Access Compliance Report

Public Rights-of-Way

Intersection ID: 46026	Main Street: BITTINGER_CT	Cross Street: PAULINE_LN	Location: NW
ADA ID: 275540BB589F	Ramp Type: BlendTrans2	Initial Pass/Fail: Fail	Overall Compliance: No
		Severity Score: 12.5

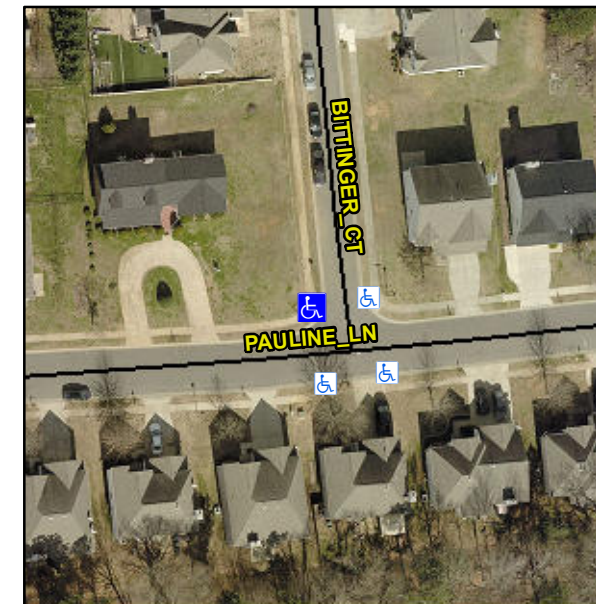
Not Found, R304.5.3

Remove & Replace Curb Ramp With Two New Directional Ramps or Equivalent.
